UNITED STATES PATENT AND TRADEMARK OFFICE

Office Action Summary	Application No. 10/655,921	Applicant(s) MANISCALCO ET AL. 	
	Examiner Andrea M. Valenti	Art Unit 3643

DETAILED ACTION

FIG. 7.

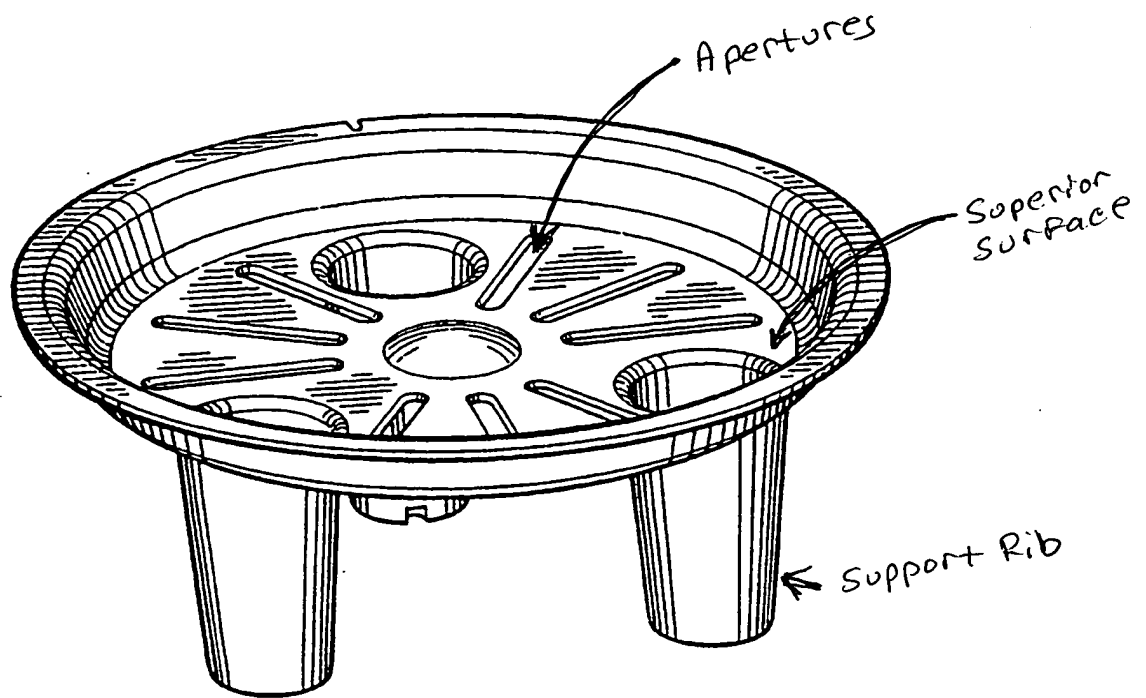
extending from the container bottom to the container rim, the inner container surface having a select container periphery intermediate the container bottom and the container rim (Fig. 2); the container insert comprising: a substantially planar superior support surface, a substantially planar inferior support surface, a peripheral support ridge, a plurality of support ribs, and a plurality of matter - receiving apertures, the peripheral support ridge comprising a sloped peripheral support surface and a peripheral support rim, the peripheral support surface being intermediate the superior support surface and the peripheral support rim, the peripheral support surface having a container - engaging depth, the support ribs being integrally formed to the inferior support surface and substantially equally spaced from one another, the matter - receiving apertures being spaced intermediate the support ribs and extending from the superior support surface to the inferior support surface, the peripheral support surface being in removably wedged engagement with the select container periphery, the container insert thus forming a false bottom in the oversized planter container at the select container periphery (please see attached Fig. 7 and 8).

Regarding Claim 32, Carlson teaches the matter - receiving apertures are defined by at least one moisture drain aperture (Fig. 7).

FIG. 8.

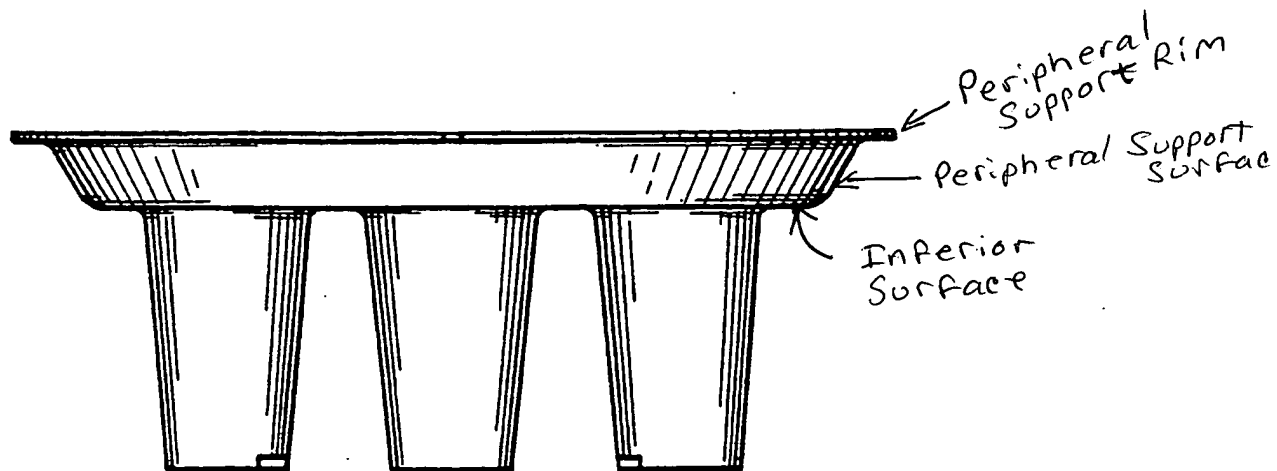
Regarding Claim 36, Carlson teaches the container insert comprises in combination manual removal means for enabling a user to manually remove the container insert from engagement with the select container periphery (Fig. 8).
